APPLICATION NO.	FILING DATE	FIRST NAMED INVENTOR	ATTORNEY DOCKET NO.	CONFIRMATION NO.
10/735,697	12/16/2003	Sung-Jae Cho	P56999	3543
ROBERT E. BUSHNELL & LAW FIRM 2029 K STREET NW SUITE 600 WASHINGTON, DC 20006-1004			EXAMINER	
			LAIOS, MARIA J	
			ART UNIT	PAPER NUMBER
			1795	
			MAIL DATE	DELIVERY MODE
			03/17/2009	PAPER

Continuation of 11. does NOT place the application in condition for allowance because:

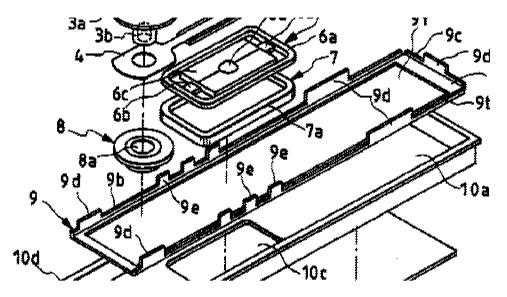
The Examiner respectfully disagrees. The external positive electrode 1 is composed of a conductve material, the surface of which is Ni plated. An upper section 1a and side plate section 1b. The sections of 1b are formed by bending both sides of the upper plate section 1a. This action forms the external positive electrode 1 into a table top form as can be seen in the figure below:

Side plate sections 1b are put into slit 2h (col. 3 lines 46-47...which state: "slit-like insertion sections 2h, 2h in which the leg portion of the external positive electrode 1 is inserted"). Therefore the side plate sections are inserted to slits 2h and welding does not occur nor does the bending of pieces 1b.
